**PLANNED UNIT DEVELOPMENT
STAFF REPORT****Date: March 5, 2015****NAME**

Audubon Properties, LLC.

LOCATION4700 & 4960 Dauphin Island Parkway
(West side of Dauphin Island Parkway, 580'± North of
Marina Drive North).**CITY COUNCIL
DISTRICT**

CONTEMPLATED USEPlanned Unit Development Approval to amend a
previously approved Planned Unit Development to allow
multiple buildings on a single building site.**TIME SCHEDULE
FOR DEVELOPMENT**

SITE PLAN

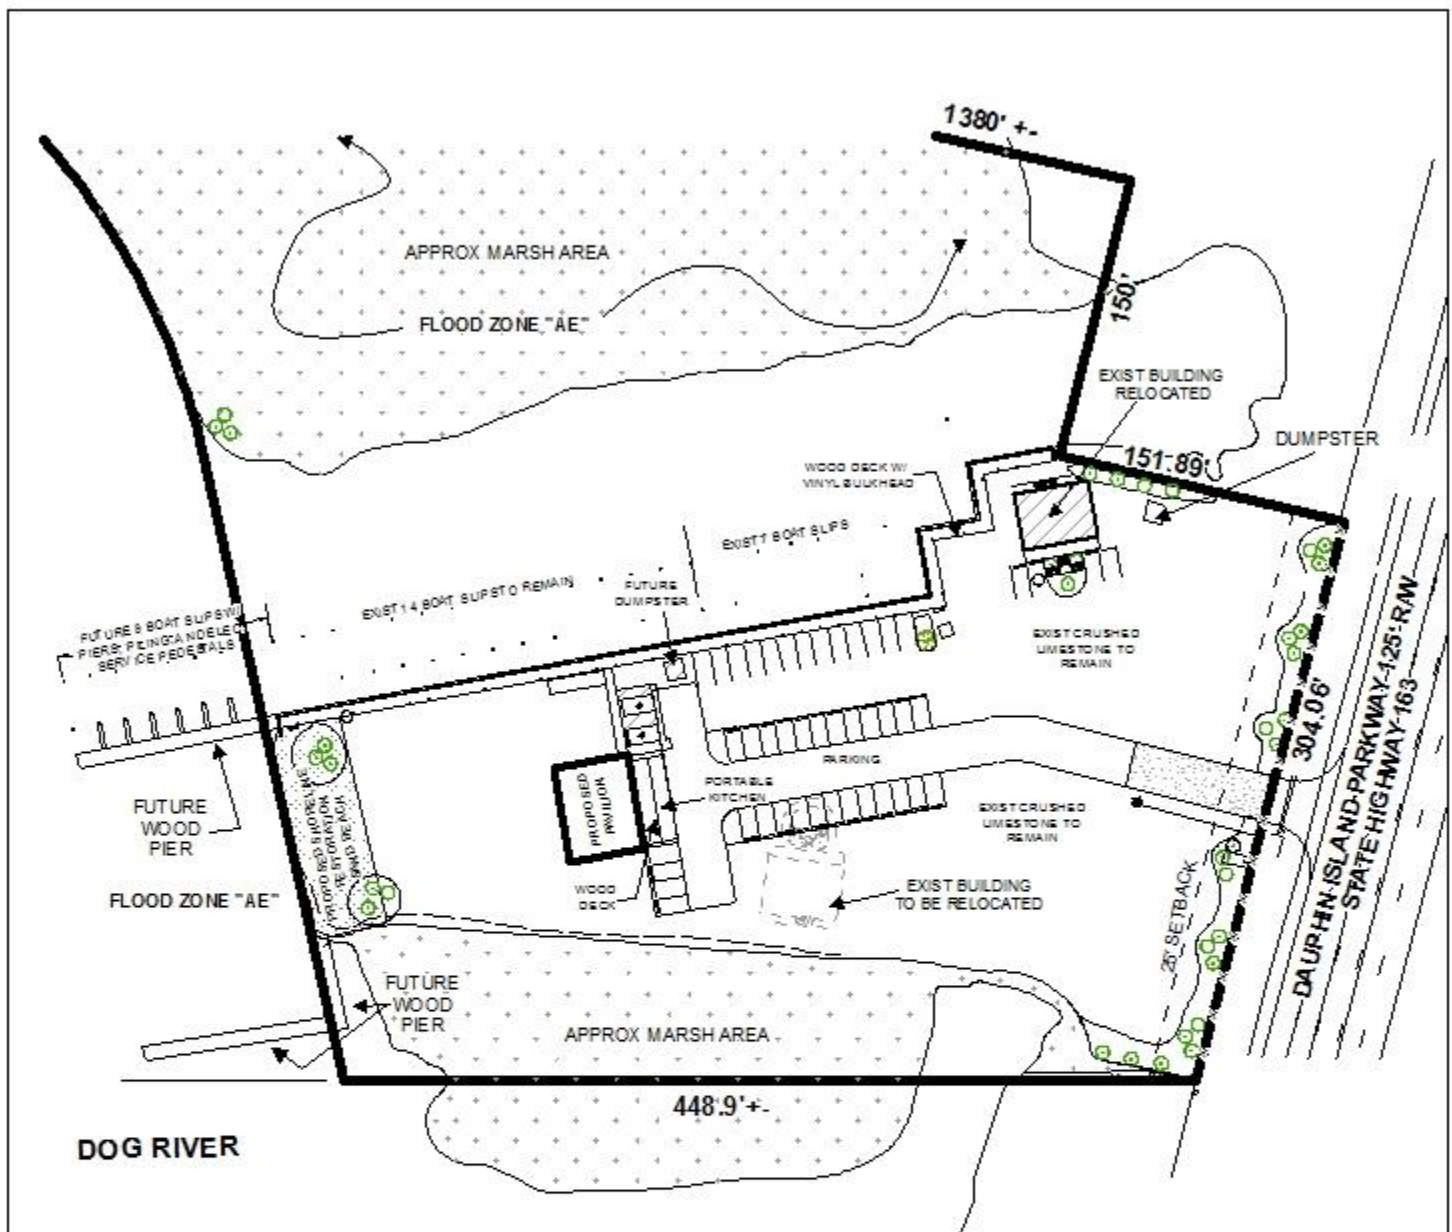
The proposed restaurant is approximately 2,810 square feet including the wood deck and portable kitchen which requires a total of 29 parking spaces. The existing office building is 1,210 square feet which requires 4 parking spaces. The marina requires 15 parking spaces; thus a minimum of 48 total parking spaces is required. A total of 47 parking spaces are depicted on the site plan although the calculations illustrated under the "Parking Data" table depict 43 parking spaces. The site plan should be revised to depict a total minimum of 48 parking spaces on the site as well as under the "Parking Data" table.

It should be pointed that the previous approval required the fire access lanes and turnaround, and all accessible parking to be paved, and in compliance with Section 64-6.A.3 of the Zoning Ordinance. This condition should also be required for this application.

It should be noted, lighting on the site will have to comply with the requirements of Sections 64-4.A.2., 64-6.A.3.c., and 64-6.A.8. of the Zoning Ordinance. The Zoning Ordinance requires all vehicle parking lots containing 25 or more vehicle spaces to provide uniform parking lot lighting; thus, a photometric plan will be required at the time of submittal for a building permit.

The site plan illustrates a dumpster in compliance with Section 64-4.D.9. of the Zoning Ordinance. However, the second proposed dumpster closest to the proposed restaurant does not indicate that it will be in compliance with Section 64-4.D.9. of the Zoning Ordinance. The site plan should be revised to depict that the dumpster will be in compliance with Section 64-4.D.9. of the Zoning Ordinance as illustrated with the previous dumpster located adjacent to the relocated office building.

The current site plan depicts a gate however there does not appear to be a note indicating that the appropriate queuing spaces will be provided, nor is there any information stating the gate will remain open at all times. The previously approved site plan depicted a note stating the following "the existing fence and gate to be modified to provide 60' queuing distance from the right of way line". The site plan should be revised to depict the same note as the previously approved site plan or a note stating that the gate will remain open at all times will be required.

Whereas the previous PUD regarded permanent buildings, the application at hand utilizes portable trailer type facilities in lieu of new permanent buildings. FEMA and the City of Mobile have specific requirements regarding trailers in flood zones.

- 1) revision of the site plan to depict a total of 48 parking spaces on the site;
- 2) revision of the site plan to provide a note stating that the existing fence and gate will be modified to provide 60' queuing distance from the right of way line, or a note on the site plan stating that the gate will remain open at all times;

- 3) submission of a photometric plan at the time of submittal of a land disturbance or building permit;
- 4) revision of the site plan to depict the proposed future dumpster to be in compliance with Section 64-4.D.9. of the Zoning Ordinance;

- 8) placement of a note on the site plan stating the required the fire access lanes and turnaround, and all accessible parking paved, and in compliance with Section 64-6.A.3 of the Zoning Ordinance;
